KEWAUNEE NUCLEAR PLANT

AMENDMENT TO FACILITY OPERATING LICENSE

Amendment No. 40 License No. DPR-43

SAFETY EVALUATION BY THE OFFICE OF NUCLEAR REACTOR REGULATION RELATED TO AMENDMENT NO. 40 TO FACILITY OPERATING LICENSE NO. DPR-43

Figure TS 3.1-1 Kewaunee Reactor Coolant System Heatup Limitations Applicable for Periods up to 10 Effective Full Power Years, Margins of 60 PSIG and 10°F are Include for Possible Instrument Error

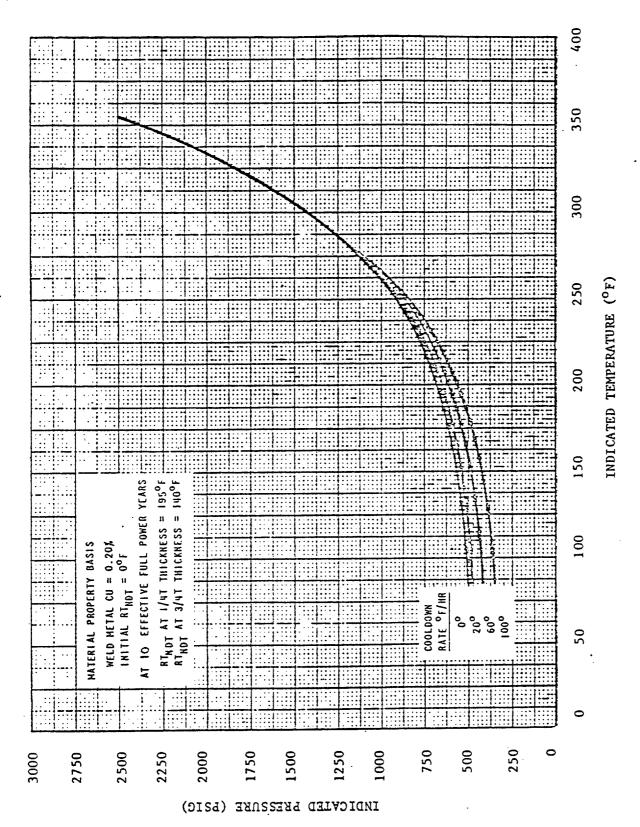
The fluence estimate, 8.3×10^{18} n/cm² (E>1 MeV), at the 1/4 T position of the beltline circumferential weld (there are no longitudinal welds) is consistent with our sources of information and is accepted. Using Reg. Guide 1.99 Rev. 1, the predicted shift, ΔRT_{NDT} , for that fluence and a copper content of 0.20% is 165°F. This is less than that indicated by the surveillance results. The reported copper content may be low. The welds for 12 other vessels made by Combustion Engineering averaged 0.32% copper, the lowest being 0.24%. Therefore, the surveillance results were used directly to check the ΔRT_{NDT} value. We find by interpolation a value of 190°F at a fluence of 8.3 x 10^{18} n/cm². Incidentally, the surveillance results are consistent with the result obtained from a mean curve fitted to the PWR surveillance data base for 0.30% Cu and 0.77% Ni.

The initial RT_{NDT} reported by WPSC is $0^{\circ}F$, which was not a measured value, but was estimated using SRP 5.3.2. From generic information about the type of weld wire and weld flux used, we find that value to be acceptable.

We conclude that the value of RT_{NDT} for the 1/4 T position (195°F), and the value of 140°F for the 3/4 T position, after 10 EFPY, given on Figures TS 3.1-1 and -2, are acceptable.

The pressure-temperature limits given in Figures TS 3.1-1 and -2 were checked against the requirements of Appendix G, 10 CFR Part 50, for the fracture toughness of the beltline and the flange areas. The staff has found that Figures TS 3.1-1 and -2 are acceptable for operating up to 10 EFPY as proposed.
